DHDC 21-8046

CERTIFICATE OF APPROPRIATENESS

**RE: Application Number 22-8046; 1531 Parker; West Village Historic District
Project Scope: Demolish existing front porch, construct new porch**

Existing Porch

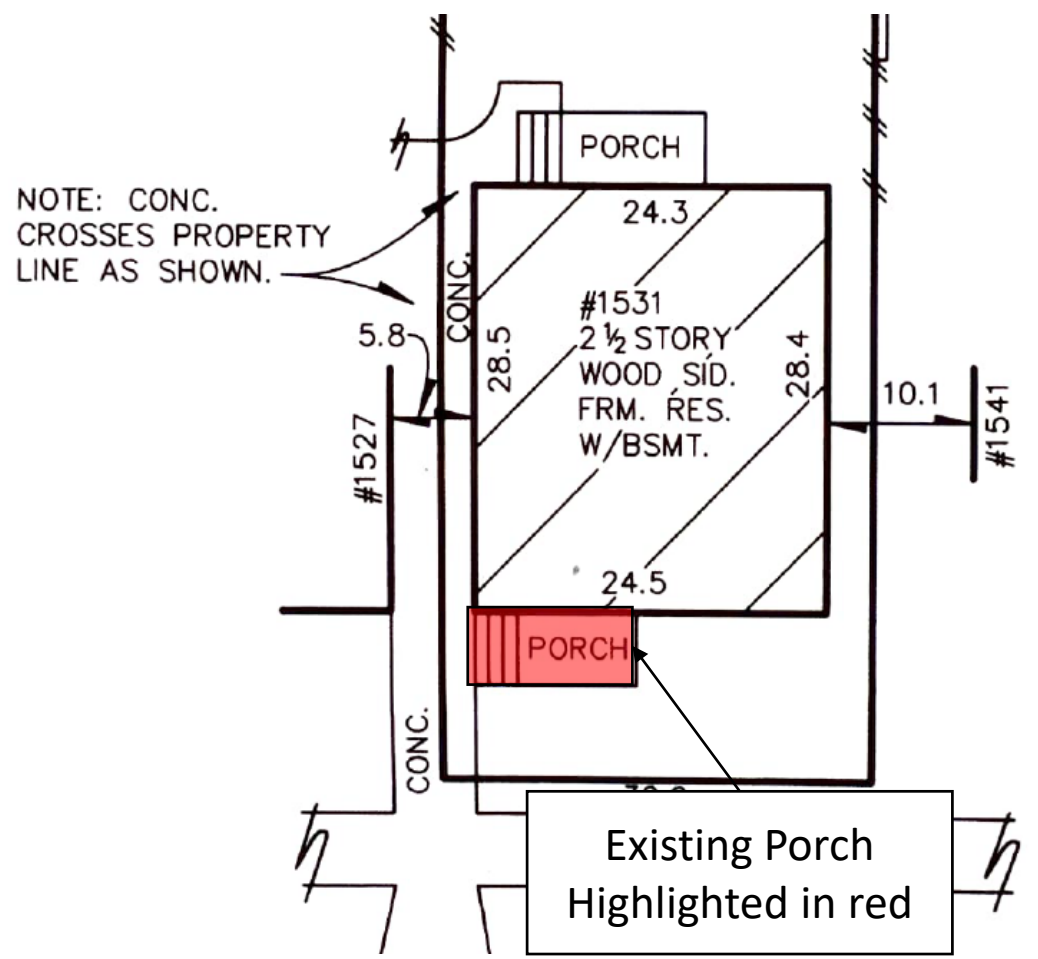
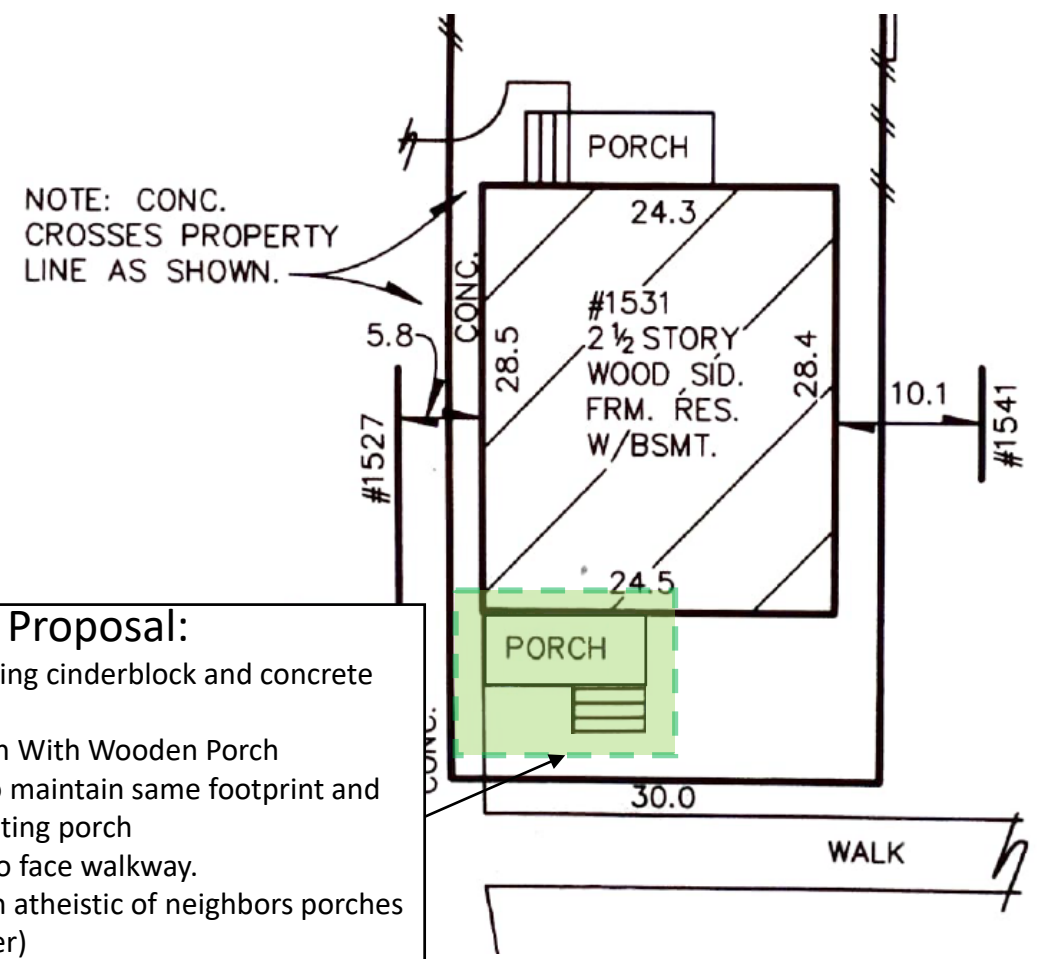
- ***A porch roof shall be added, meeting the Secretary of the Interior’s Standards for Rehabilitation, subject to approval by staff, incorporating the historic elements still extant (i.e, the pediment and columns), which may be repositioned.***
